SHEARON HARRIS NUCLEAR POWER PLANT, UNIT NO. 1
DOCKET NO. 50-400/LICENSE NO. NPF-63
CYCLE 15 CORE OPERATING LIMITS REPORT - REVISION 1

SUMMARY OF CYCLE 15 COLR REVISION 1

Figure 8
Cycle 15 V(Z) Versus Core Height
18000 MWD/MTU ≤ burnup ≤ 21463 MWD/MTU

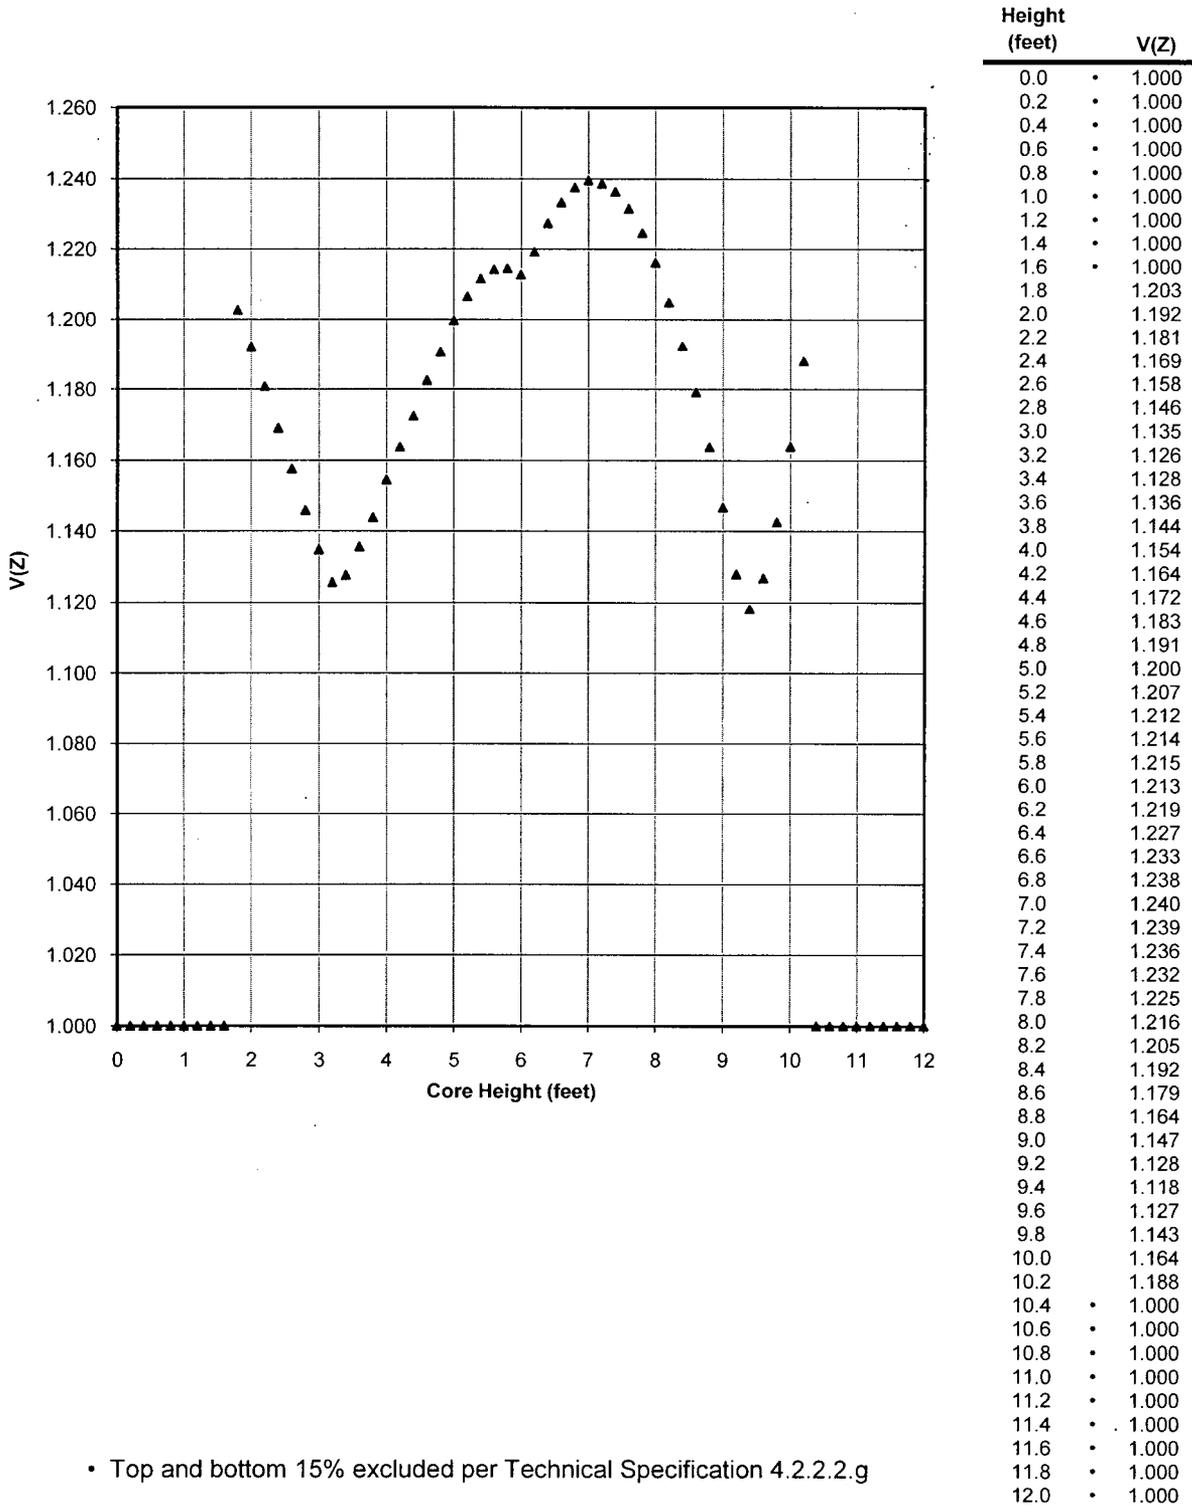
<u>Section</u>	<u>Description of Change</u>
All	Updated title on each page of Attachment 9 from Revision 0 to Revision 1.
Attachment 9 Sheet 2 of 15	In 2.6.2 at bottom of page, revised 21340 MWD/MTU to 21463 MWD/MTU.
Attachment 9 Sheet 15 of 15	Revised 21340 MWD/MTU to 21463 MWD/MTU in the Figure 8 title.
